# BionX<sup>®</sup>

Unlike the previous BionX<sup>®</sup> motors, the SL motors do not have a pressed on torque reaction collar. The new version is slotted, and does not require the use of a puller to remove or reposition. The BionX Limited Edition SL XL kits will all include the standard 27° torque reaction collar.

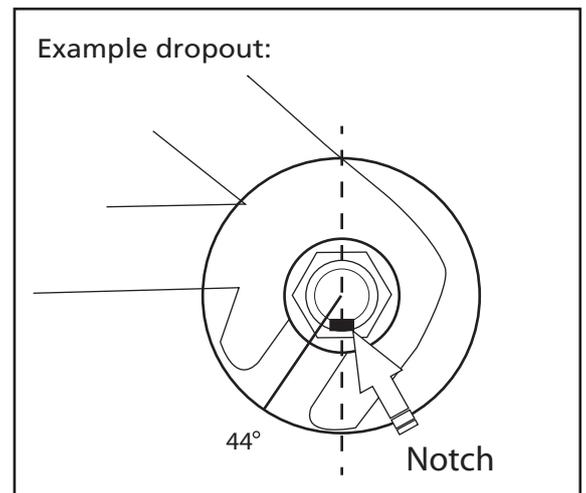
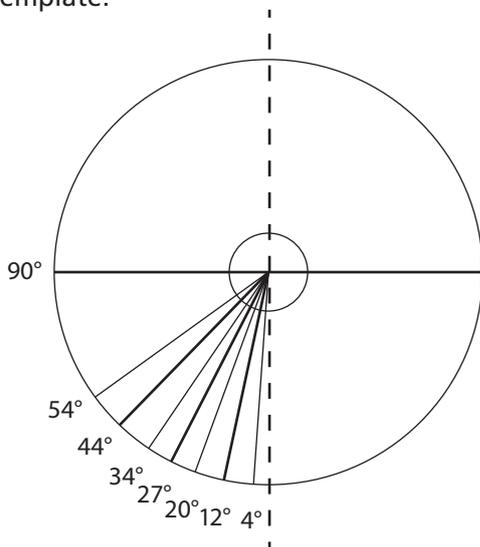
The new SL motors, like the original G1 BionX motor, require that the axle notch be oriented in the 6 o'clock position for the torque sensor to function correctly. If the axle notch does not point in the 6 o'clock direction, the following alternate collars can be ordered from BionX:
